AGENDA - TROY PLANNING COMMISSION MEETING
WEDNESDAY, MAY 28, 2025, 3:30 P.M.
CITY HALL, COUNCIL CHAMBERS

SUBJECT: Certificate of Appropriateness – 101-103 S. Market Street

SUBJECT: Certificate of Appropriateness – 12-16 S. Market Street

SIGN ONE
ONE - DOME STYLE AWNING W/ SIGN PANEL, ONE SECTION
FRAMES MILL FINISH
#6003 JOCKEY RED SUNBRELLA (60") FABRIC
VINYL GRAPHICS APPLIED
NO LIGHTS
NO EGGRATE
SHIPPED LOOSE:
(8) Z-CLIPS

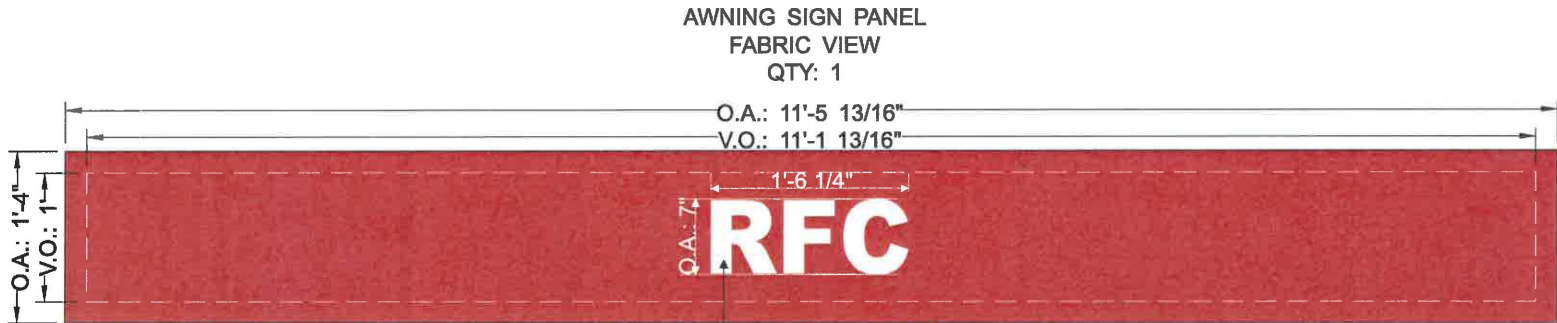
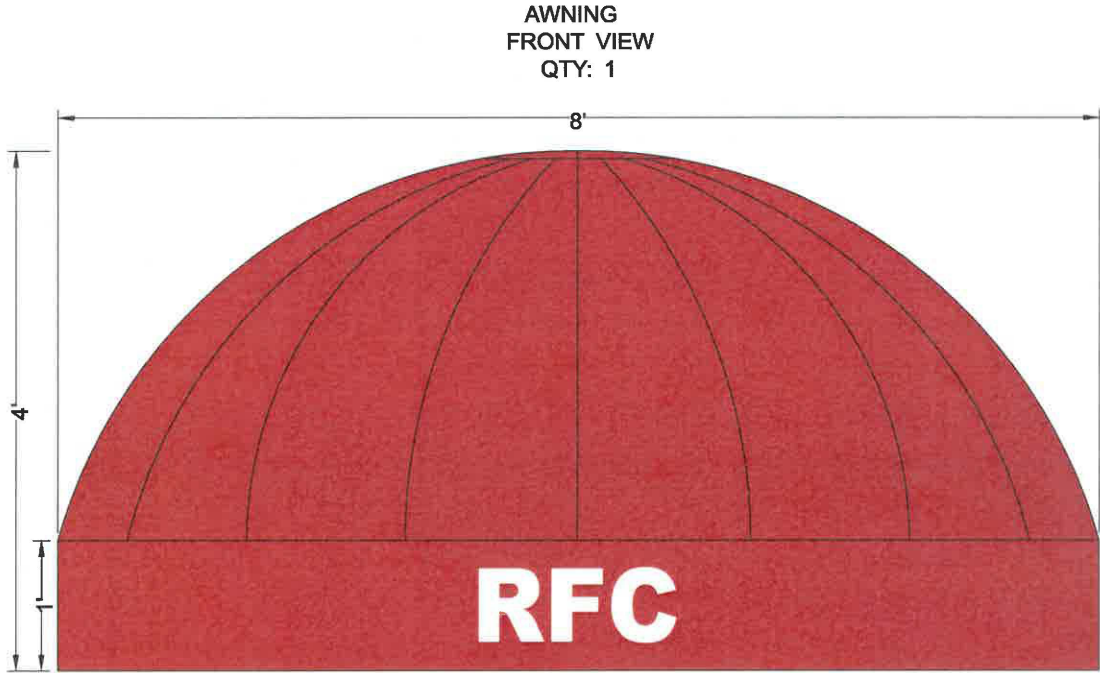
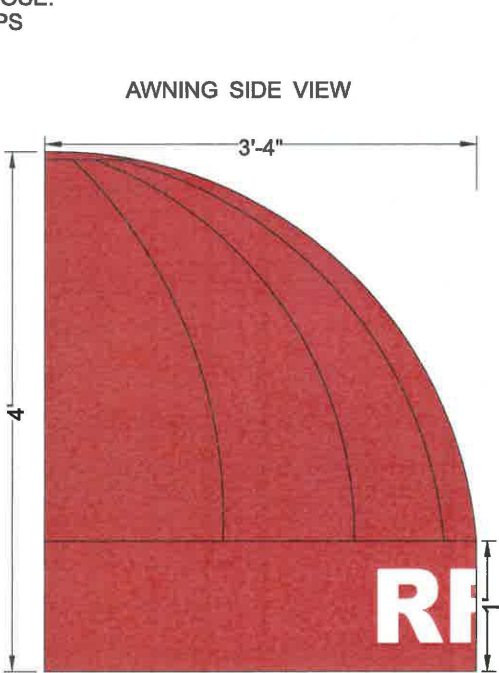
Awning. The applicant proposes replacement of the existing awning with the same design and material. The color will be red with white lettering at a height of eight (8) feet above the parking lot. The awning will include “RFC” lettering covering an area of 0.75 square feet.

Section 2.11 A. Fabric awnings are preferred and shall have a matte surface. **The awning will be a fabric material and have a matte surface. The proposal meets this guideline.**

Section 2.11 B. Avoid fixed, permanent canopies unless it can be documented through research that a building had one in the past or the canopy design is compatible with the original character of the building and the district. **The replacement awning will be identical to the existing awning. The proposal meets this guideline.**

Section 2.11 C. Each window or door should have its own awning, rather than a single full-width awning covering an entire façade. **The awning is covering a single door. The proposal meets this guideline.**

Section 2.11 D. A traditional flat, sloped awning design should be used. Selection of open-end versus closed-end awnings should be historically based. **The replacement awning will be identical to the existing awning. The proposal meets this guideline.**

Section 2.11 E. Awning color(s) should complement the building and be compatible with historically appropriate colors used on the building, but avoid overly ornate patterns and too many colors. A simple pattern using no more than two colors is preferred. **The replacement awning will be identical to the existing awning. The proposal meets this guideline.**

Section 5.6 A. Awning sign designs should be coordinated with the architectural character of the storefront. The use of stripes and scalloped edges should be minimized unless there is substantial evidence that the detail is historically appropriate. **The replacement awning will be identical to the existing awning. The proposal meets this guideline.**

Section 5.6 B. Awning signs should include simple text and logos on subdued backgrounds. **The proposal will have simple text and logos and will meet this guideline.**

Staff recommends approval of the awning due to the compliance with Design Manual Sections 2.11.

Staff recommends approval of the awning sign due to the compliance with Design Manual Sections 5.6.

REVISED MARKET ST ELEVATION - TECHNICAL

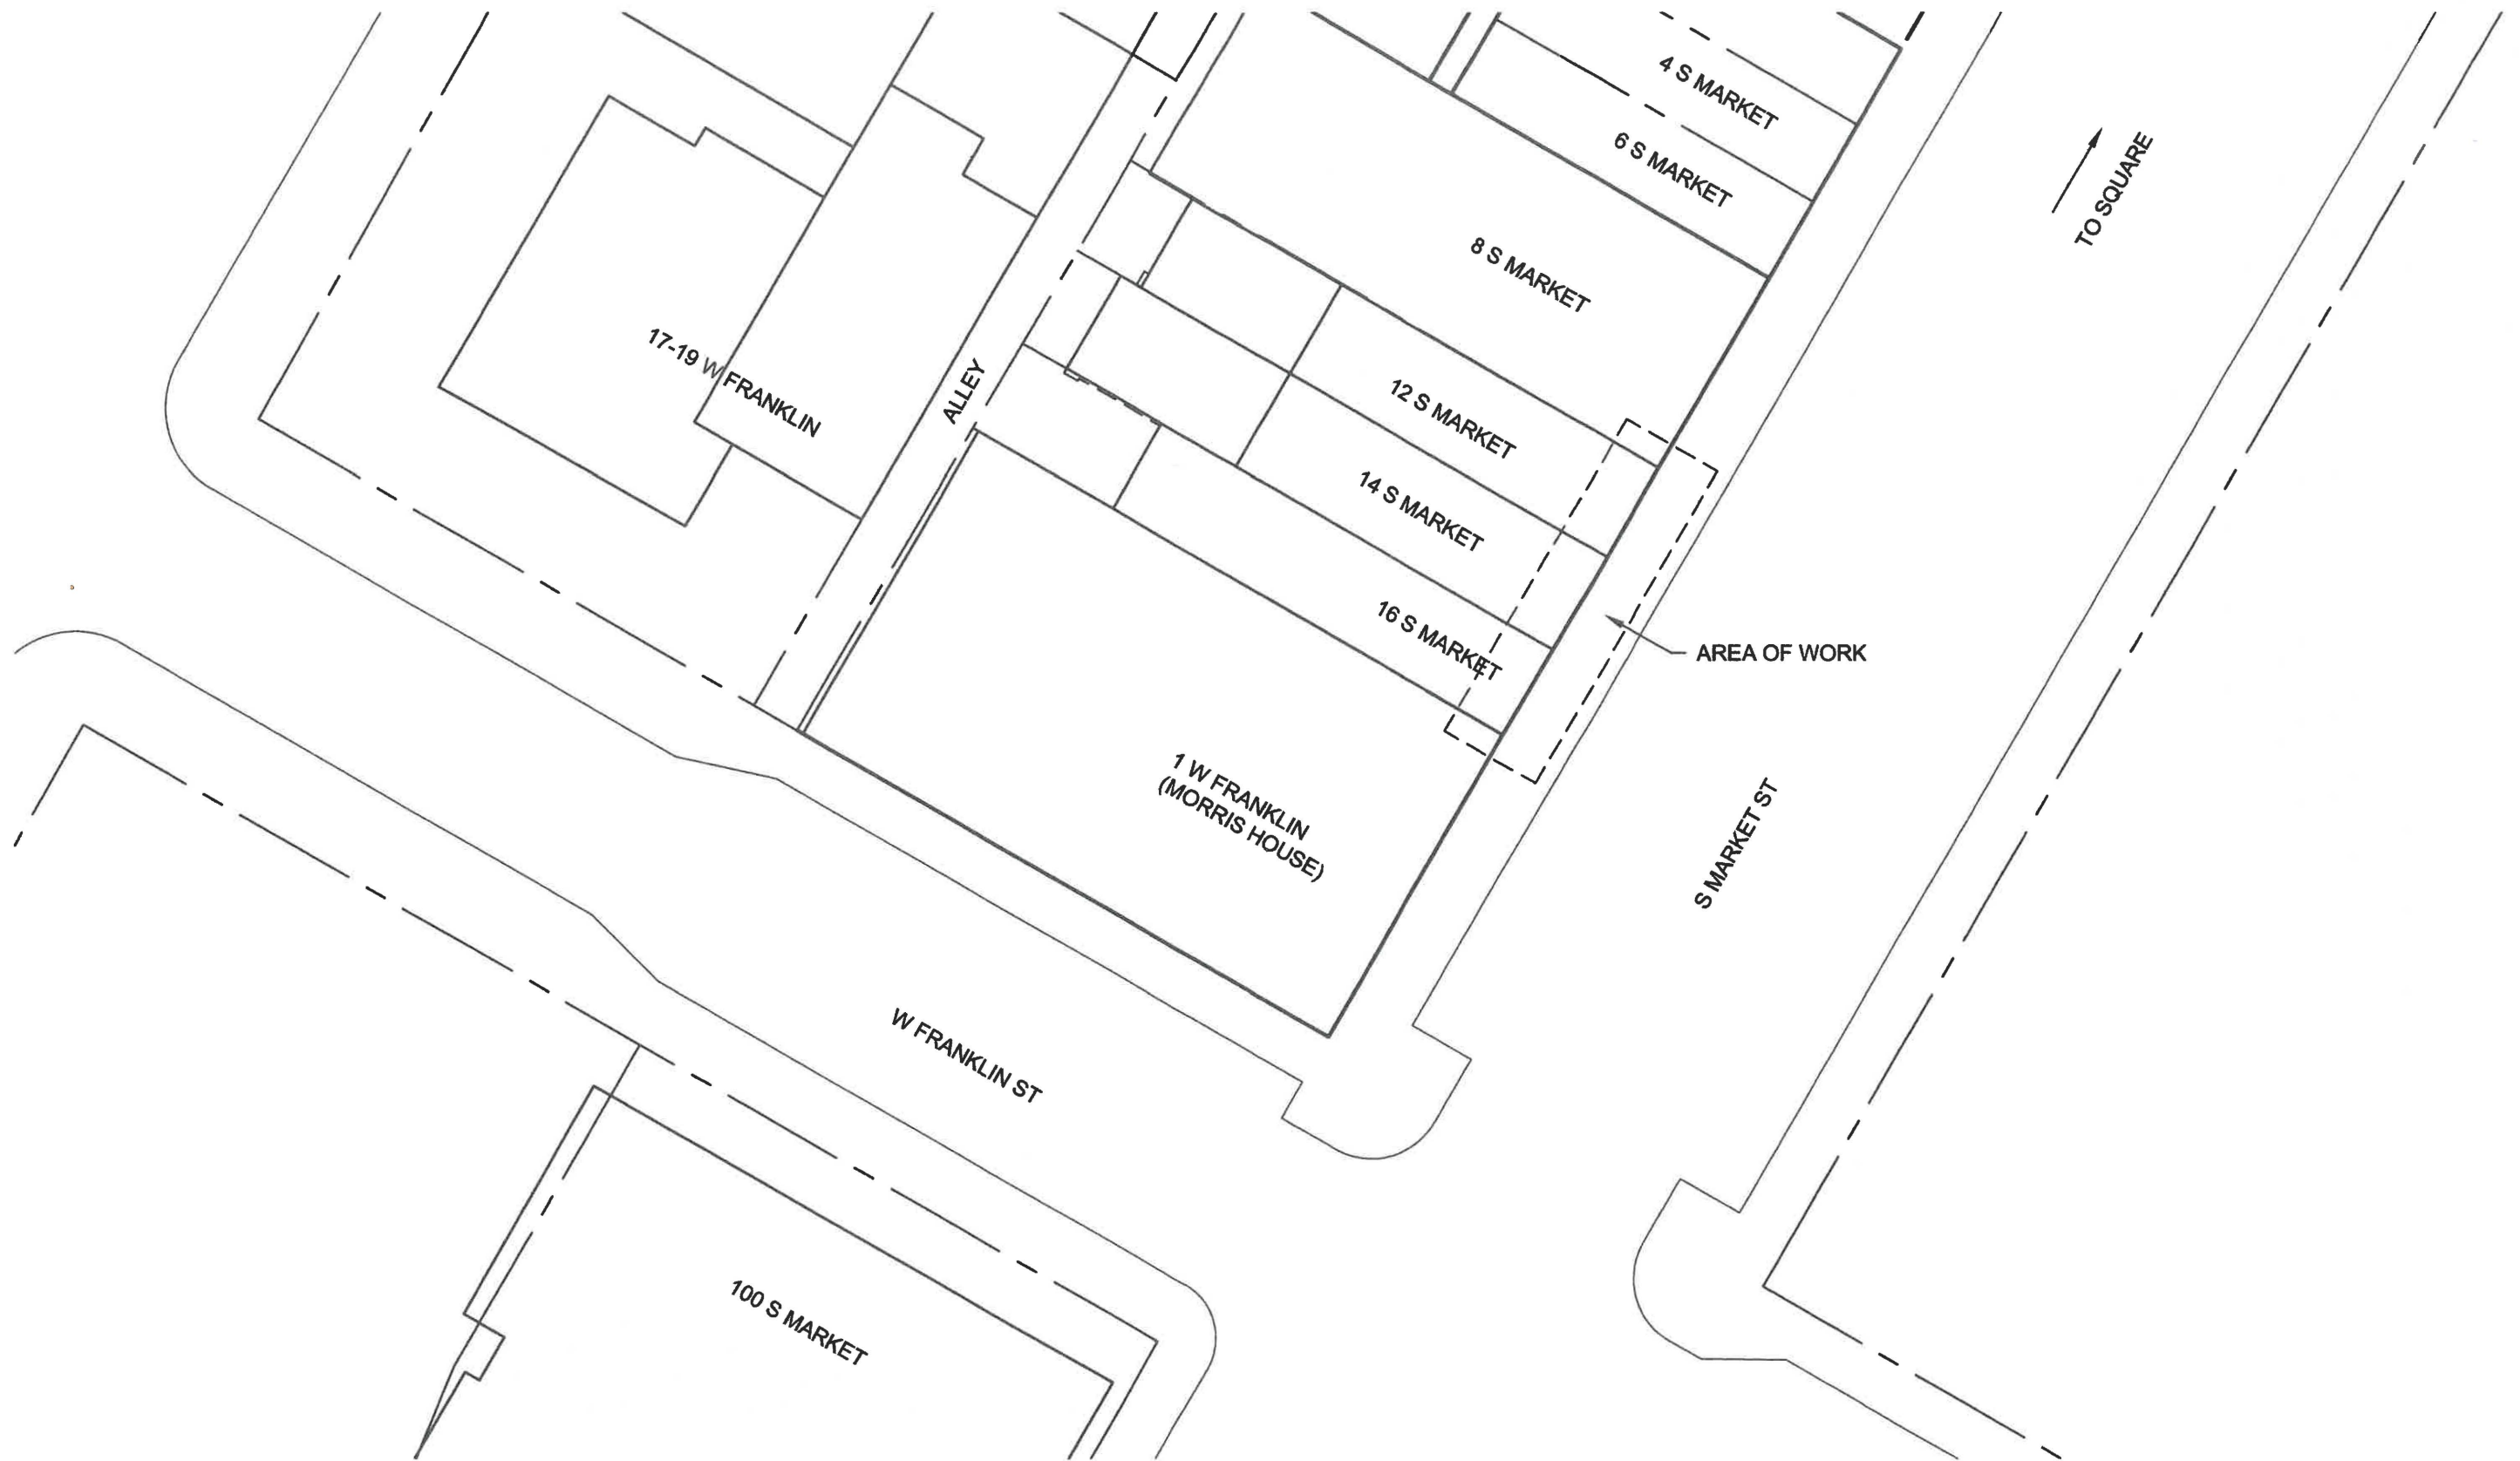
Storefront Alteration. The red painted metal panels, awning, and storefront that includes the stone clad knee walls are proposed for removal. This will expose the details underneath for evaluation. It is important to note that if the storefront details are in too bad shape or need significant modifications to the design that was submitted, the applicant will make a new application to the Planning Commission (see attached existing conditions).

Windows. The applicant is proposing to replace ten (10) windows with Pella Monumental Style Wood Windows that are wrapped in aluminum clad in the Sherwin Williamis Library Pewter (SW 0038) color.

Section 2.15 A. Designs should be consistent with the historic storefront character, including window sizes and architectural features. **The proposal would bring back the original characteristics of the storefront. The proposal complies with this guideline.**

Section 2.15 B. Storefronts should retain ornamentation and trim consistent with the historic architectural style of the building. **The proposal would bring back the original characteristics of the storefront. The proposal complies with this guideline.**

Section 2.15 C. Avoid “theme” restorations (e.g. Colonial, Bavarian, Art Deco, Post Modern, etc.) unless historically true to the building. **The proposal would bring back the historically true characteristics of the storefront. The proposal complies with this guideline.**

Section 2.15 D. Materials should be consistent with the historic architectural style of the building. Inappropriate designs and materials should be avoided such as diagonal wood siding, vinyl or aluminum siding, mansard roofs, and fixed metal canopies. **The proposal will bring back the original wood designs and materials of the storefront. The proposal complies with this guideline.**

Section 2.15 E. Piers, columns, or pilasters that separate a storefront into distinctive bays shall be preserved. **The original columns will be preserved. The proposal complies with this guideline.**

Section 2.15 F. The size of the storefront opening shall not be reduced. Transparency and scale are very important to storefronts and their relations to the remainder of the building. The size of the storefront will not be altered. **The proposal complies with this guideline.**

Section 2.8 A. The position, number, and arrangement of original windows in a building should be preserved. The position, number, and arrangement of the original windows are being preserved. The proposal meets this guideline.

Section 2.8 B. If original windows are extensively deteriorated, only the deteriorated windows should be replaced. Avoid removing any that are still repairable. The windows are single pane and have sustained water damage. The proposal meets this guideline. See attached photos.

Section 2.8 C. Avoid enlarging or downsizing window openings to accommodate replacement window sizes. The proposal will retain the original window openings. The proposal meets this guideline.

Section 2.8 D. Replacement windows should match the appearance of the historic originals in number of panes, dimensions of sash members, and profile of sash members and muntins. Windows should simulate the operating characteristics of the originals. The same material as the original windows, usually wood, should be used. The replacement windows will be Pella Monumental Wood windows that are wrapped in aluminum clad. The number of muntins and depth will be identical to the original windows. The proposal meets this guideline.

Staff recommends approval of the storefront alteration with the following condition:

1. If the storefront material underneath the metal is too far gone or otherwise requires any changes, a new application is made to the Planning Commission.

Staff recommends approval of the paint due to the compliance with Design Manual Section 2.6 as outlined above.

Staff recommends approval of the windows due to the compliance with Design Manual Section 2.8 as outlined above.

REVISED MARKET ST ELEVATION - RENDERED

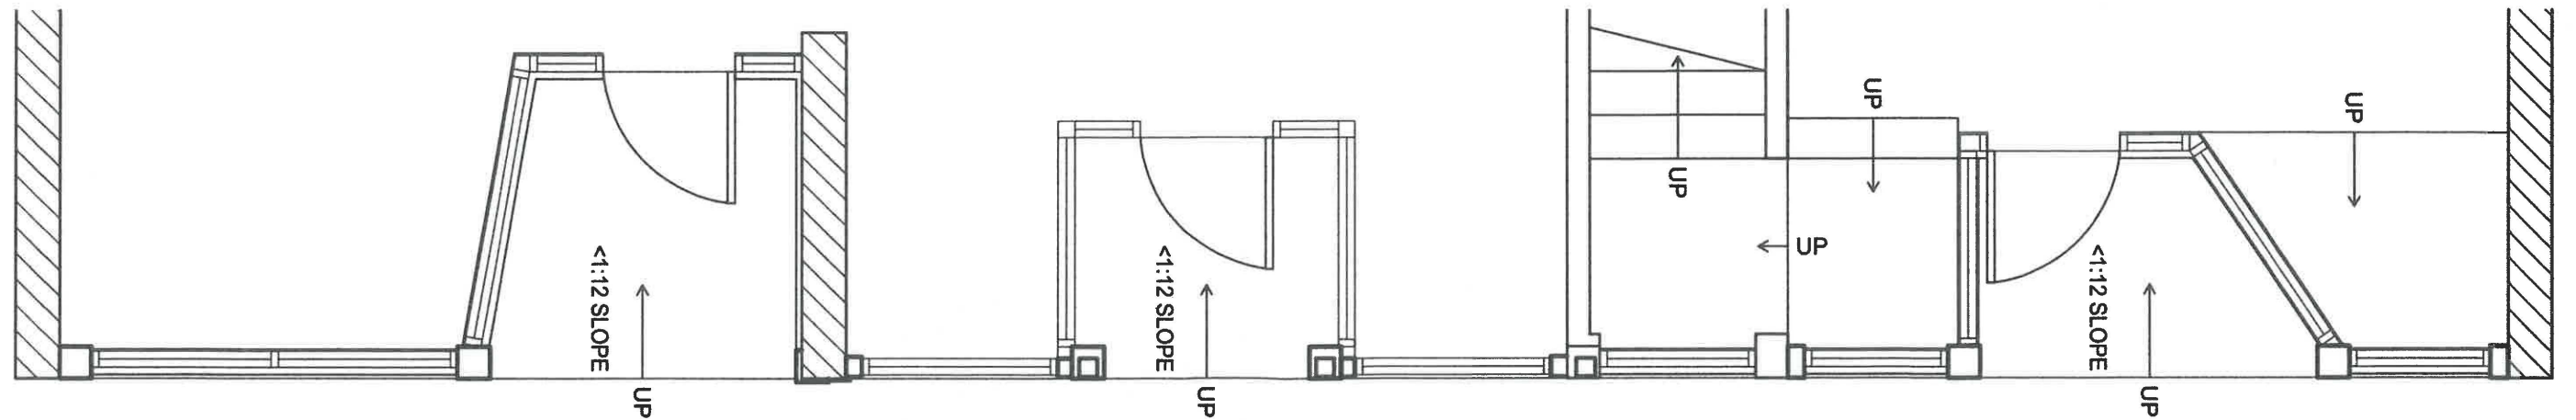
Paint. The applicant proposes painting the main body color Sherwin Williams Studio Blue Green (SW 0047). The accent trim will be painted both Sherwin Williams Classic Light Buff (SW 0050) and Library Pewter (SW 0038). On the south side of the building, the applicant proposes to paint the storefront Sherwin Williams Garden Grove (SW 6445). See attached design graphics:

Section 2.6 A. A concentration of similar colors on the same block should be avoided. **Similar colors on the same block are being avoided. The proposal meets this guideline.**

Section 2.6 B. Historically unpainted surfaces should not be painted. Historically painted surfaces should remain painted. **The unpainted surfaces are remaining unpainted. The proposal meets this guideline.**

Section 2.6 C. Simpler buildings should have a simple color scheme. More ornate structures, such as larger Queen Anne styles, may incorporate three or more colors. **The proposal will have a simple color scheme and will meet this guideline.**

Section 2.6 D. Matte, flat, or semi-gloss paint should be used. Avoid high gloss paint. **High gloss paint will be avoided. The proposal will meet this guideline.**

Section 2.6 E. In all circumstances, avoid bright and obtrusive colors, such as neon or day-glow hues. **Bright, obtrusive, and neon colors are being avoided. The proposal meets this guideline.**
